Subject: Oconee Nuclear Station  
Docket Numbers 50-269, 270, and 287  
Supplemental Response to Request for Additional  
Information Pertaining to Defense in Depth and  
Diversity Assessment Associated with the Digital  
Upgrade of Oconee's Reactor Protective System and  
Engineered Safeguards Protective System

### NRC Request for Additional Information (RAI) Associated with the Digital Upgrade of Oconee's Reactor Protective System and Engineered Safeguards Protective System

#### RAI 7

Figure A-1

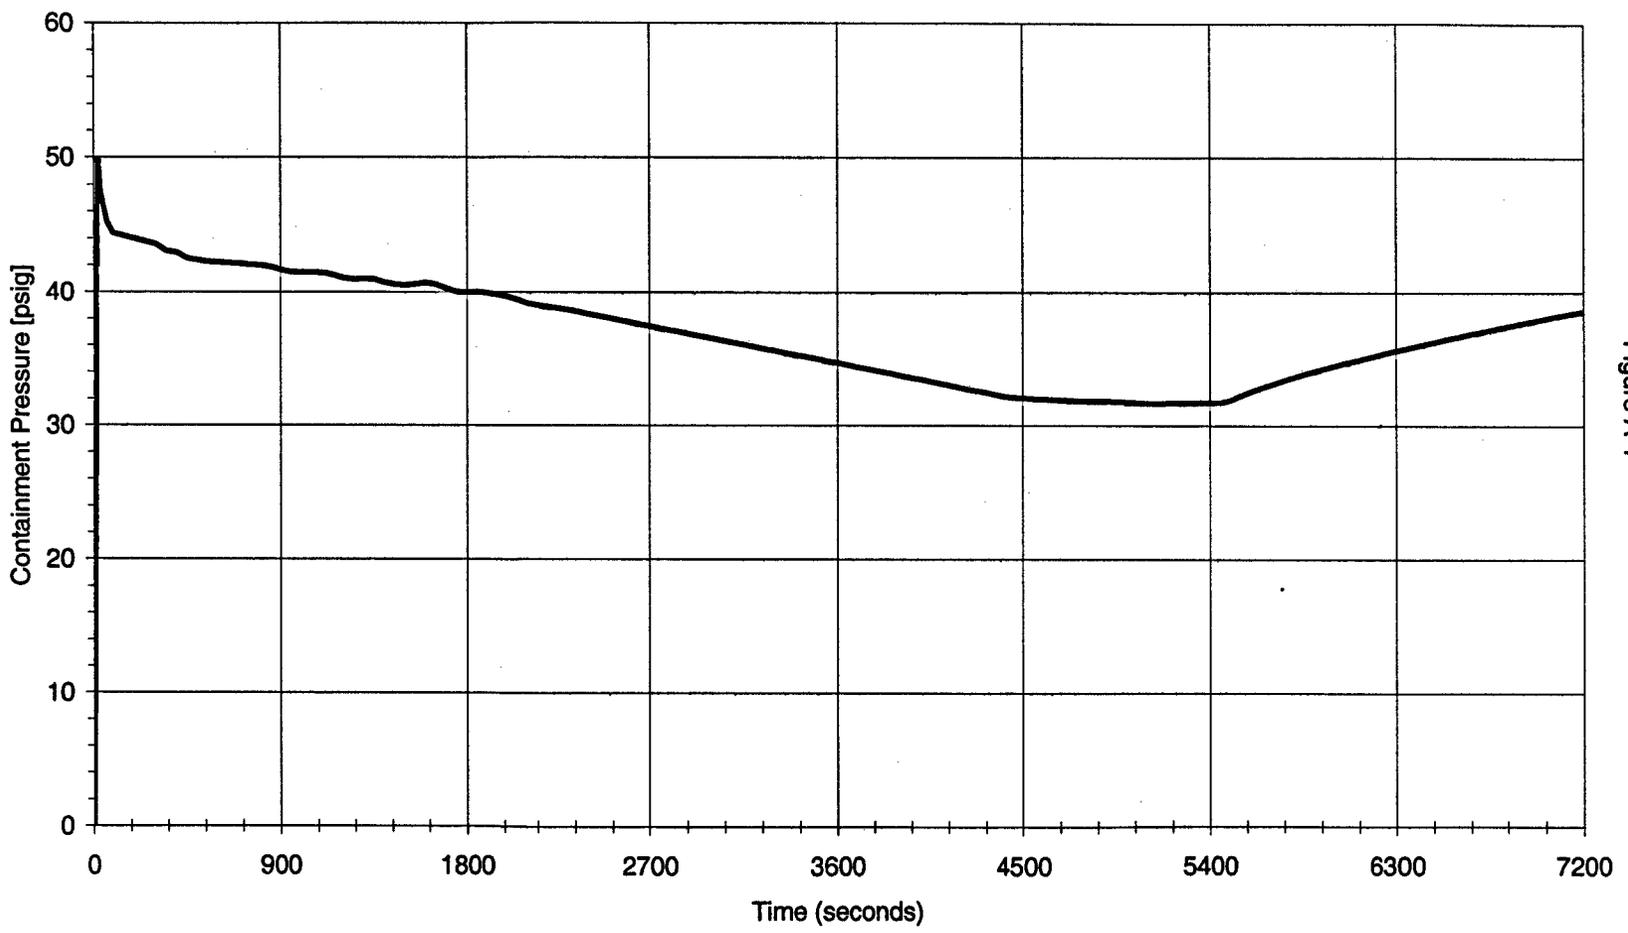
How much time *is available for operators to take the actions such that accident acceptance criteria are met (reactor coolant system overpressure, radiological, reactor building pressure, coolable geometry)?*

To demonstrate this effect, a design basis large break LOCA case was reanalyzed without actuation of either the RBCS or RBS. The containment pressure response is presented in Figure A-1 for the initial 2 hours of the case. As illustrated in Figure A-1, the initial pressure peak is not exceeded for the initial hour of the event, as pressure continues to decrease. RB pressure does begin to increase, but only after 1.5 hours has elapsed. This case assumes prompt ECCS injection to the RCS. In order to provide a continuous mass and energy release, it is necessary to assume that either prompt operator action is taken to initiate HPI and LPI, or that the ES actuation for these functions is not affected by an Reactor Protective System (RPS)/Engineered Safeguards Protective System (ESPS) software common mode failure. Thus it may be concluded that variations in the operator action time to initiate HPI and LPI are not critical for this acceptance criterion.

Figure A-2

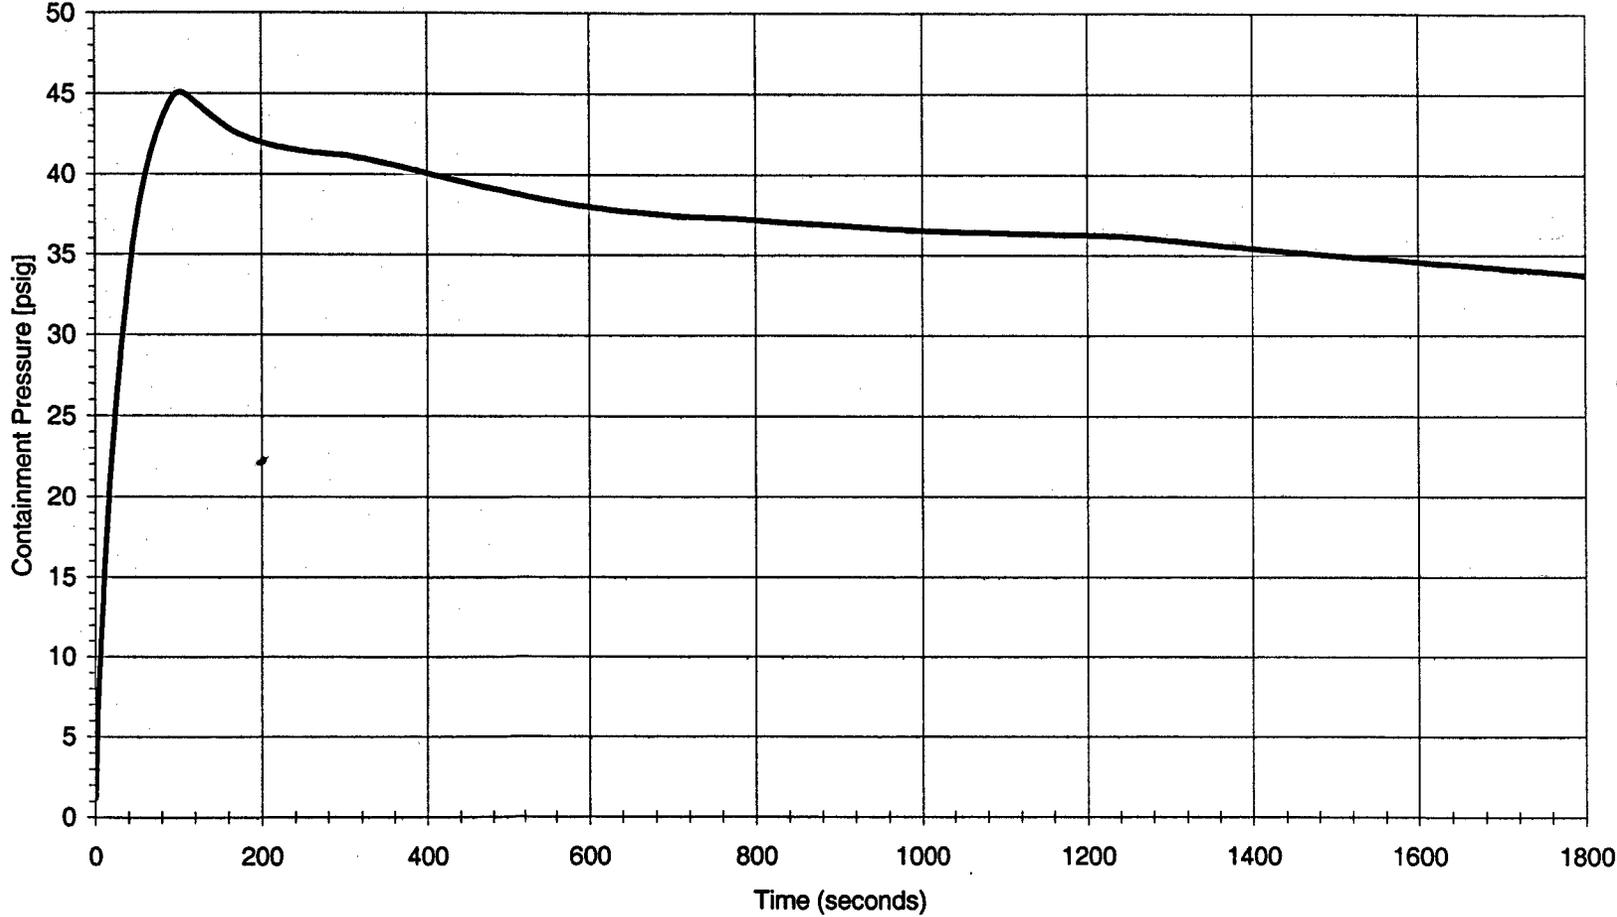
The containment pressure response for a REA will be bounded by that of the SBLOCA identified in Reference 1. The containment pressure response for both of these break sizes is bounded by that of the large break LOCA presented in Figure A-1. For comparison, the containment pressure response for a CFLB with assumptions obtained from Reference 1 is presented in Figure A-2. Thus, it is reasonable to conclude that the RB pressure acceptance criterion will not be affected by reasonable variations in the operator action times to actuate HPI, RBCS and RBS.

Figure A-3

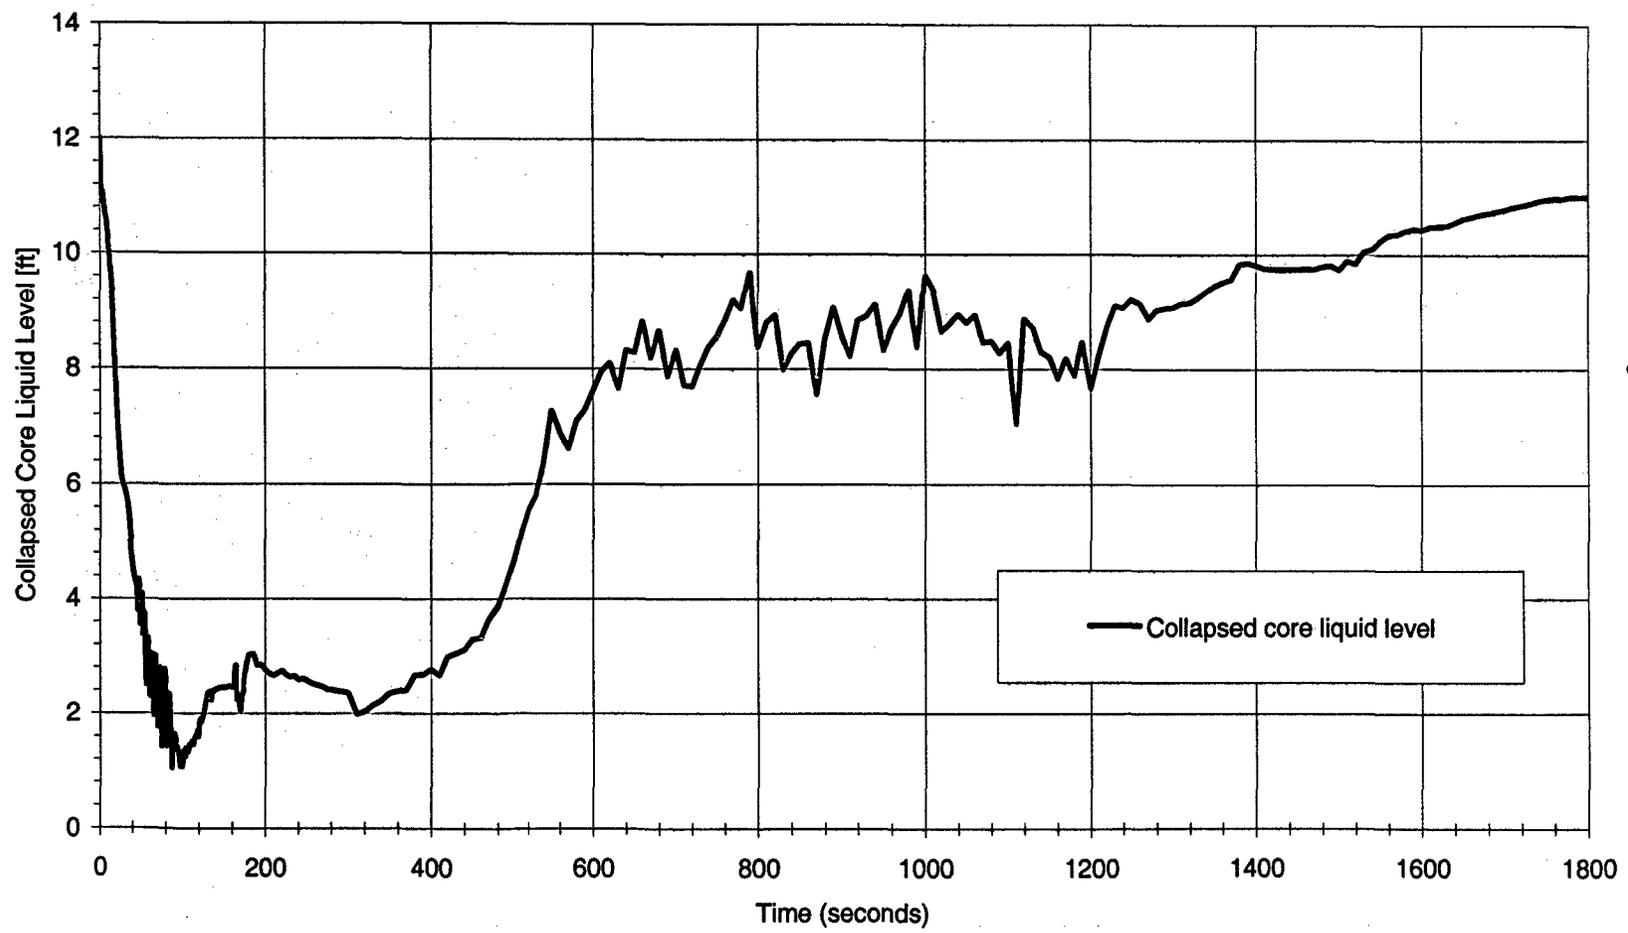
The first case is a simulation using the operator action times identified in this RAI. This case makes similar assumptions relative to the timing of ECCS injection and reactor trip as the Framatome-ANP RELAP5 analysis. The resulting collapsed core liquid level and clad surface temperatures indicate that adequate heat transfer is maintained. This result is consistent with the results of the Framatome-ANP RELAP5 analysis. The collapsed core liquid level for this case is provided on Figure A-3. The clad surface temperatures for the upper half of the core are provided on Figure A-4.

Figure A-5

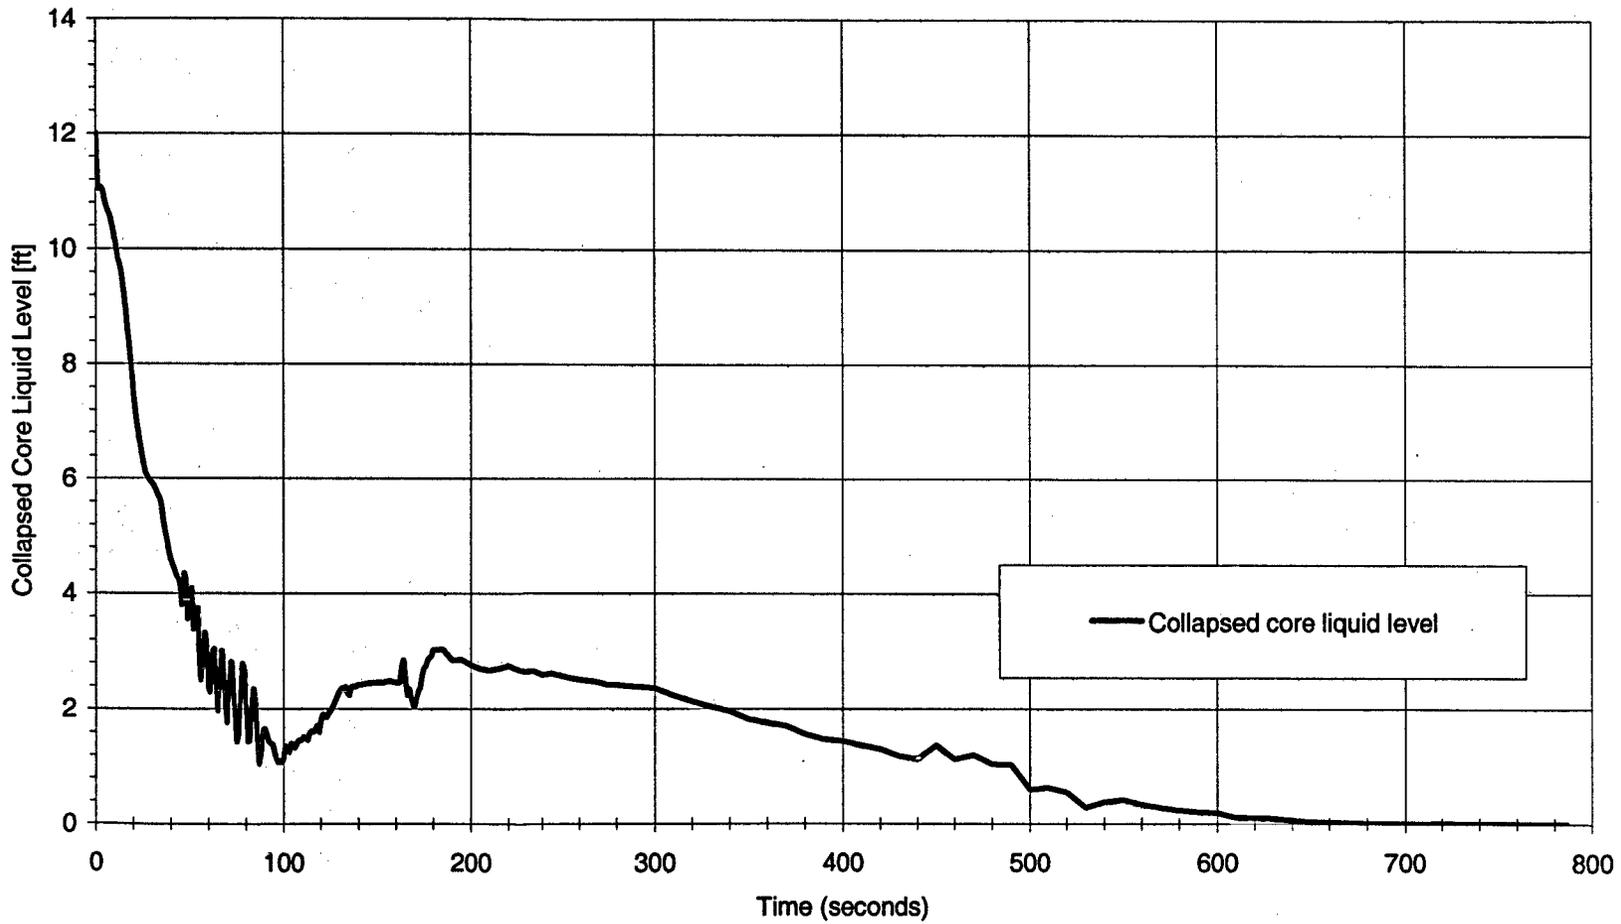
The second case assumes no operator action to actuate ECCS injection. This case is identical to the first case, with the exception that ECCS is not actuated. The collapsed core liquid level

for this case is provided on Figure A-5. The clad surface temperatures for the upper half of the core are provided on Figure A-6. As illustrated on Figure A-6, the cladding surface temperature for the uppermost core node begins to depart from the fluid saturation temperature of about 330°F at approximately 320 seconds. The amount of time available is estimated using the Framatome-ANP RELAP5 case result of a maximum clad temperature in the average channel of about 1000°F, and a maximum allowable clad temperature of 1800°F. Since the metal-water reaction is expected to become significant at 1800°F, no additional time beyond this point is considered. A cladding surface temperature increase of 800°F is used to estimate the available time for operator action. The highest node clad temperature reaches 1130°F at about 500 seconds. The time difference between the beginning of the temperature increase and the time when the cladding surface temperature increases by 800°F defines the additional available operator action time. This would indicate that approximately 180 seconds of additional time is available for operator action.

Figure A-7

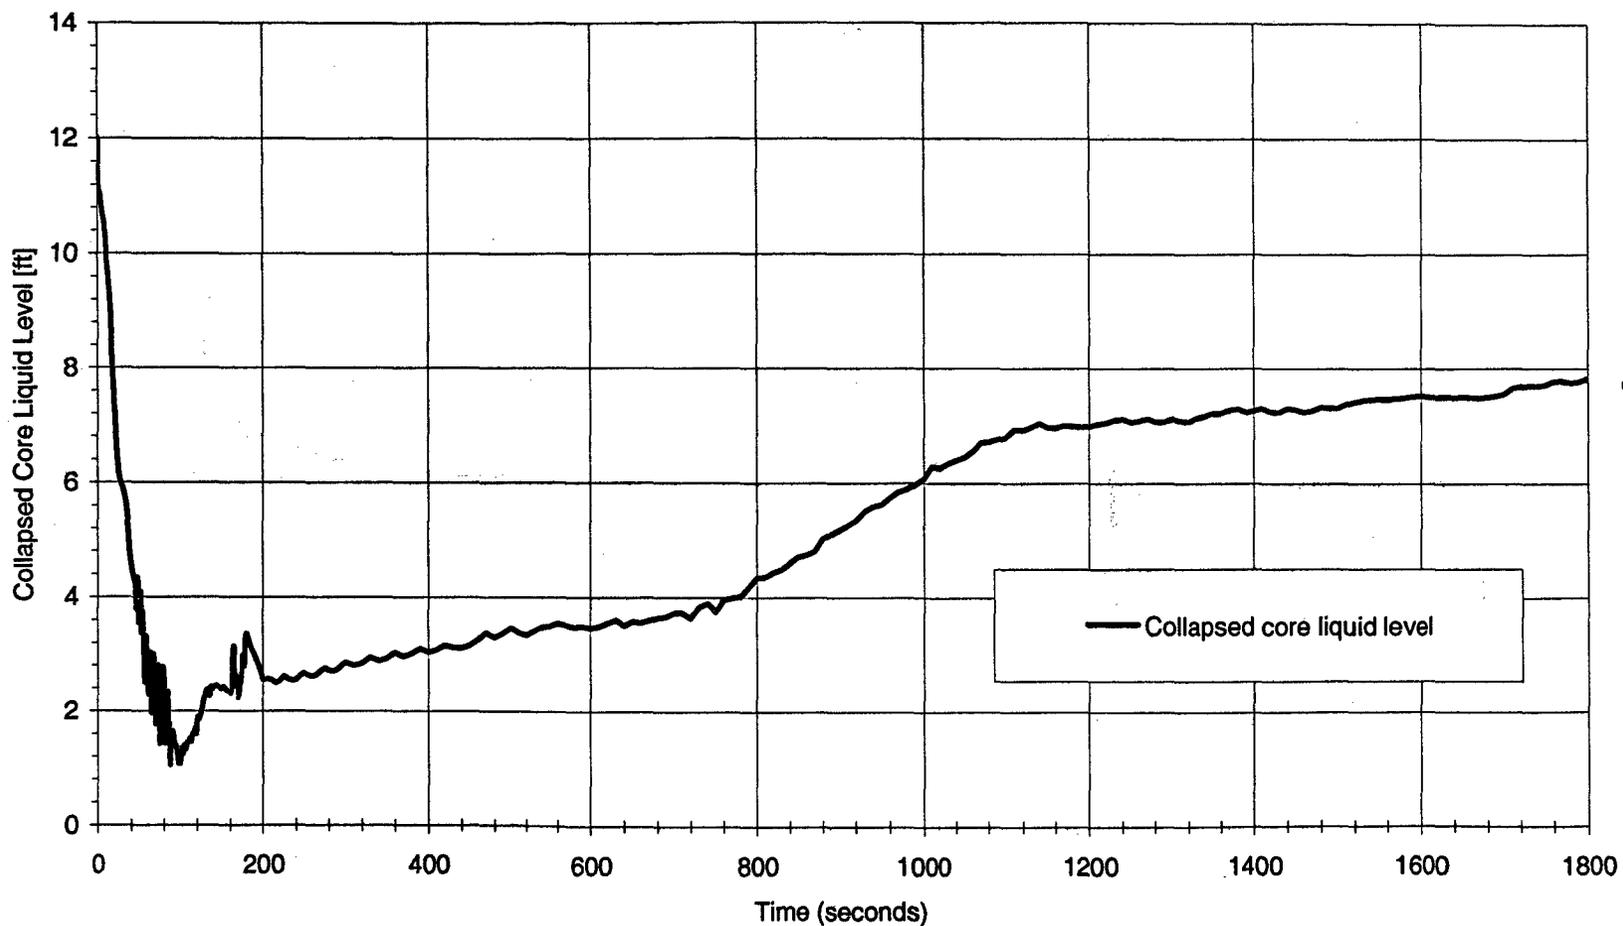
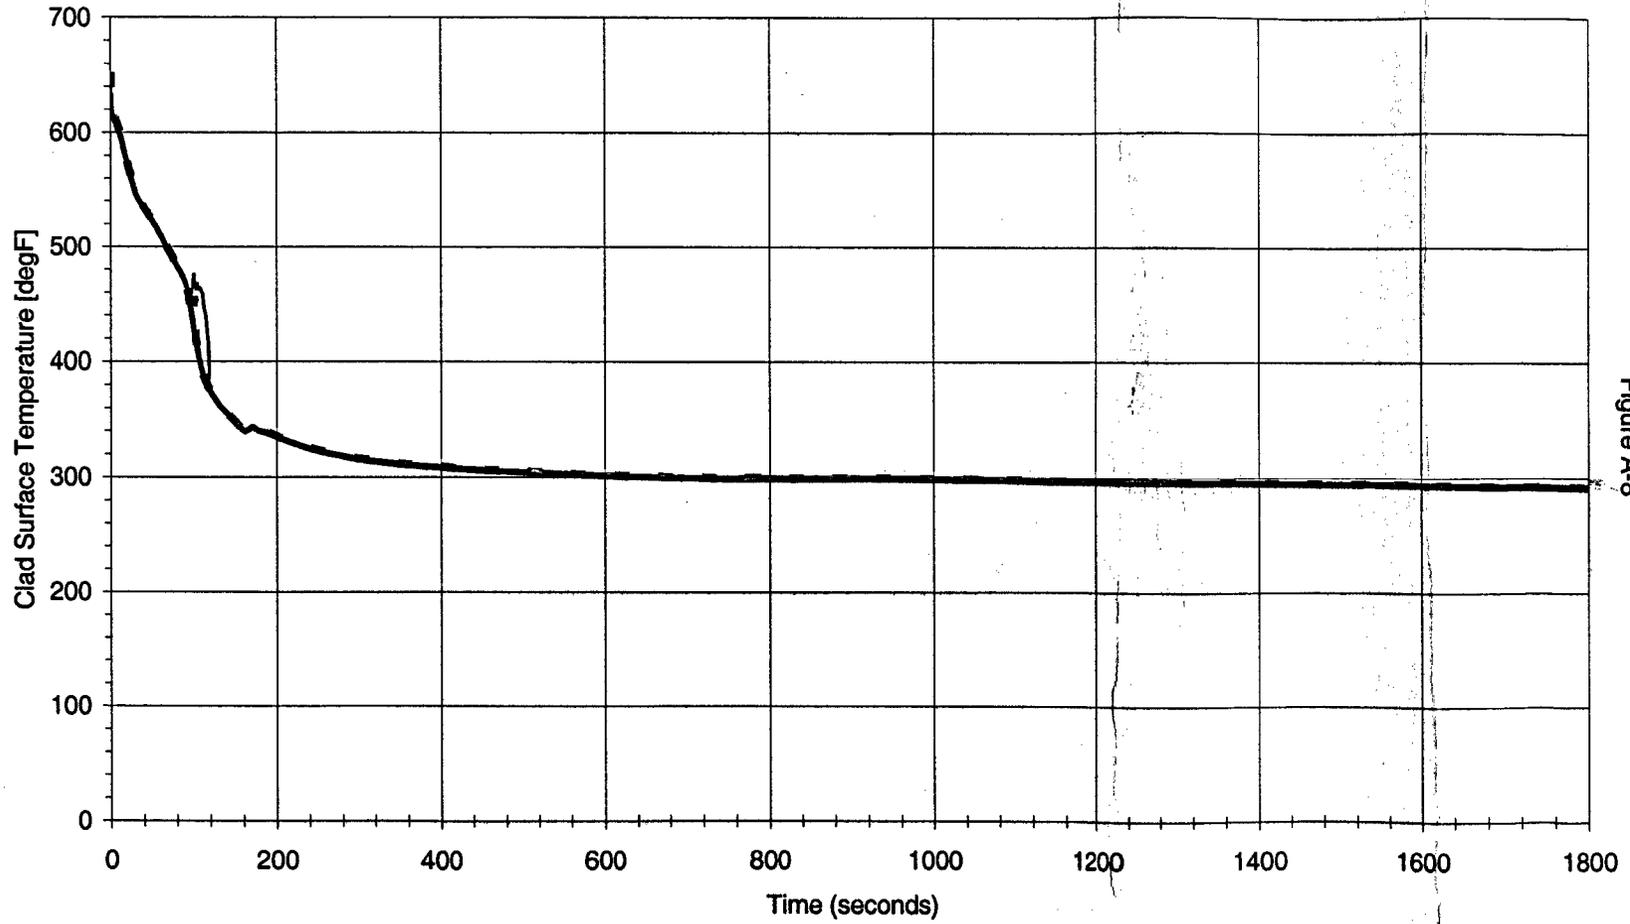
The third case evaluates the impact of a diverse LPI actuation for a double-ended CFLB. This case is identical to the first case, with the exception that LPI is actuated at 120 seconds. The time selected is expected to bound the timing of the proposed diverse LPI actuation. The normal 3 pump HPI flow rate exceeds the LPI injected flow rate for a CFLB. The collapsed core liquid level for this case is provided on Figure A-7. The clad surface temperatures for the upper half of the core are provided on Figure A-8. The results of this case indicate that once LPI is actuated, the collapsed core liquid level continuously increases, and clad surface temperatures indicate that adequate heat transfer is maintained. Thus, it may be concluded that for a CFLB with a diverse LPI actuation, the operator action time to initiate HPI flow is not critical.
